#### Addendum No. 002

January 14, 2022

ODOT - Eaton Outpost DOT-200023

Prepared For: Ohio Department of Transportation / Ohio Facilities Construction Commission

PLUMBING STACKS

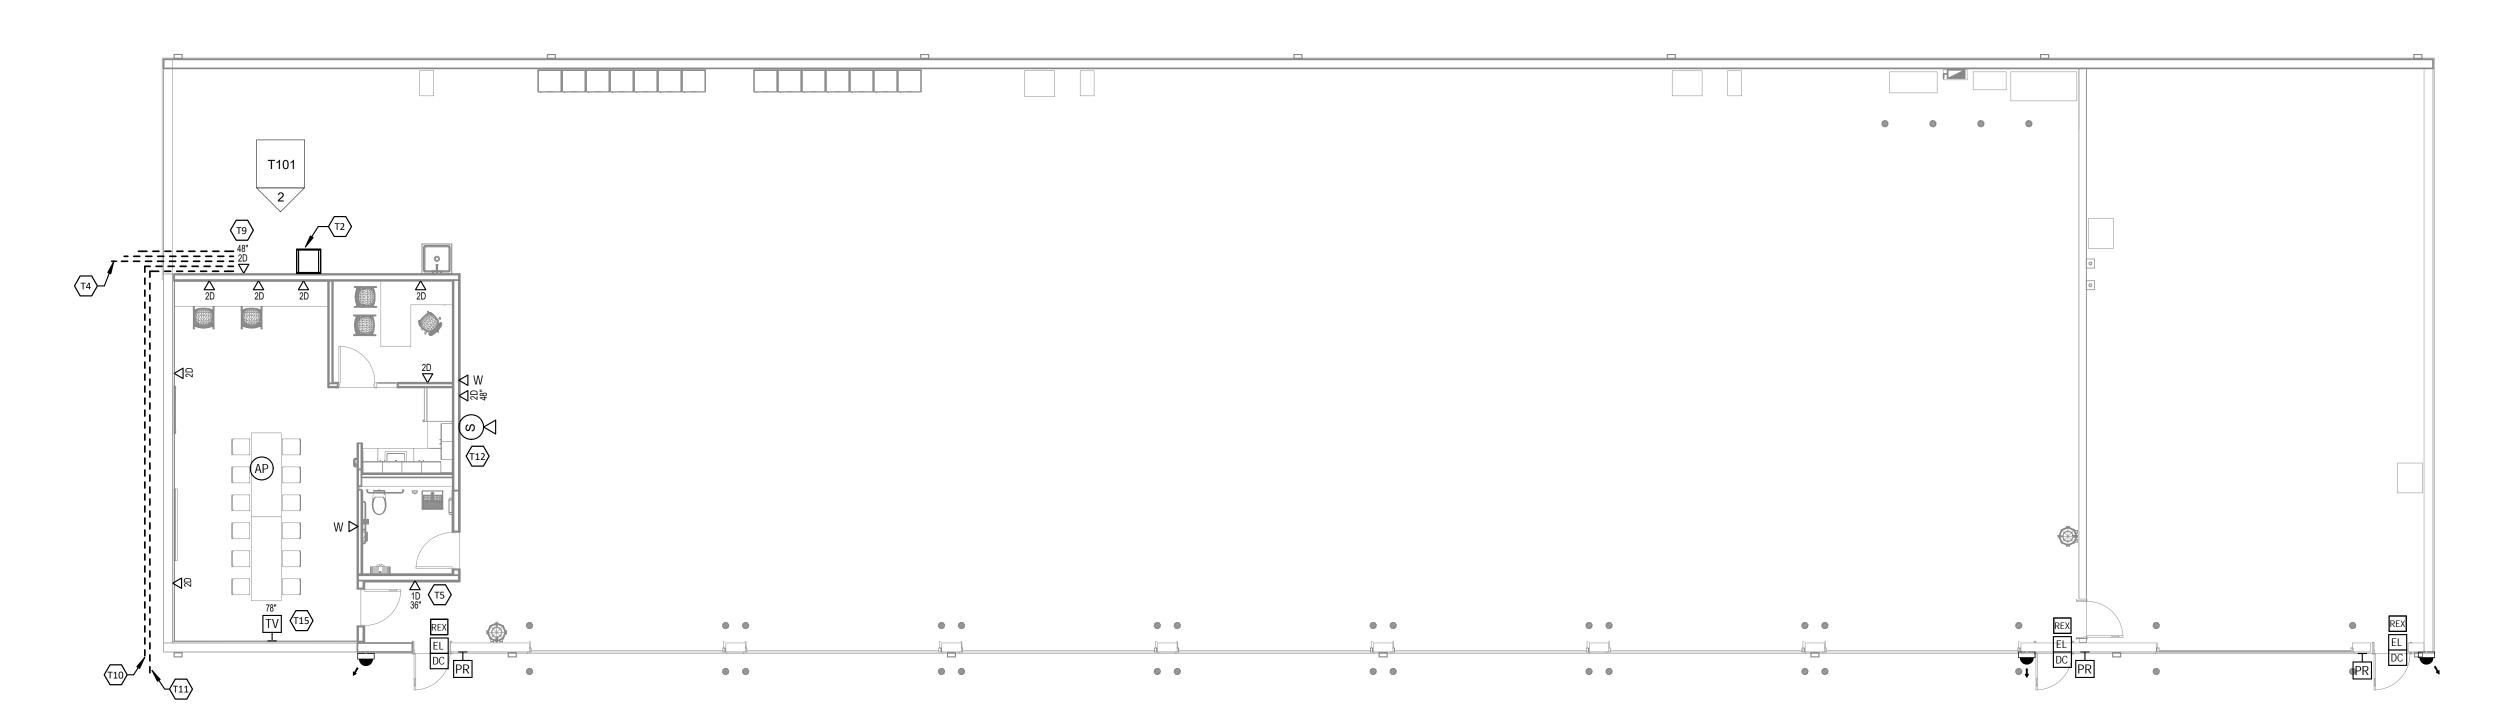
#### **Revise Sheet P901 – PLUMBING STACKS (Revised Sheet Attached)**

Revise riser diagram as clouded to accommodate back outlet WC-1 and BF-1.

- A. BF-1 has been added to revised Sheets P401 and P901 attached herein.
- **Q5:** "In reviewing the plumbing drawings I cannot locate BFP-3 or the brine system that it is to serve. Is this backflow preventer still required? If so, where is it to be located?"

1 FIRST FLOOR OVERALL TECHNOLOGY PLAN
T101 1/8" = 1'-0"
0 8' 16' 32'

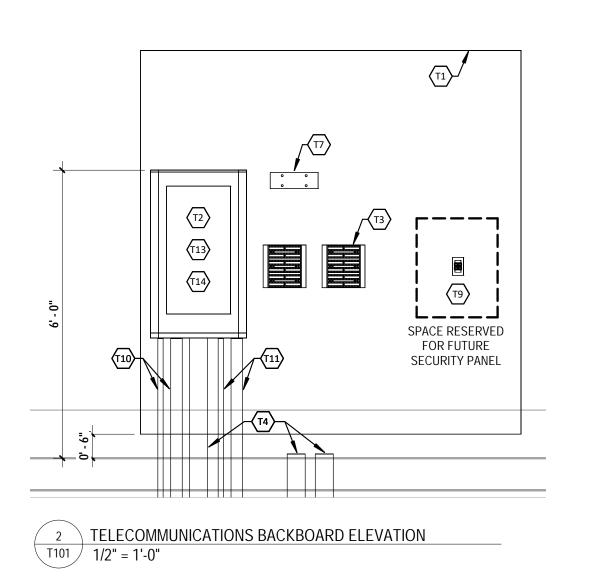
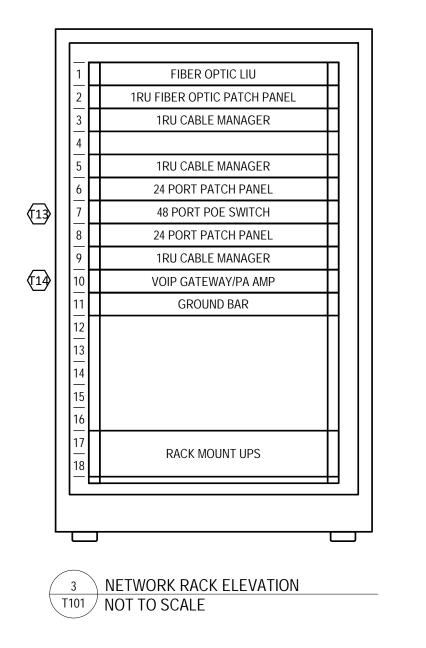
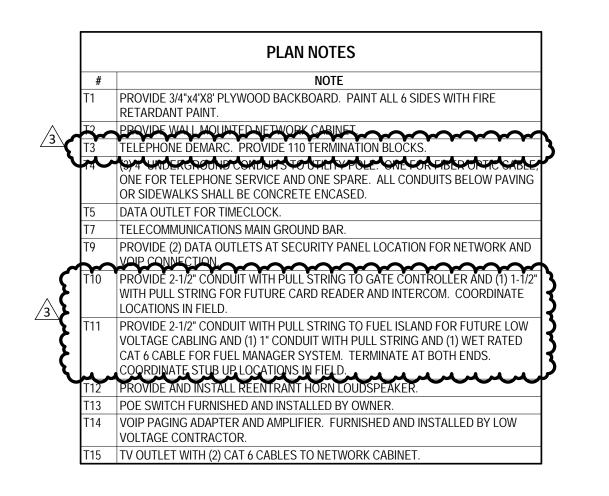
#### **Revise Sheet T101 – FIRST FLOOR TECHNOLOGY (Revised Sheet Attached)**

Plan Note T3 – Revise note as clouded to include 110 termination blocks.

Plan Note T10 – Revise note as clouded to remove requirement for wet rated Cat 6 cable to gate controller.

Plan Note T11 – Revise note as clouded to clarify conduit and cabling requirements for fuel island.
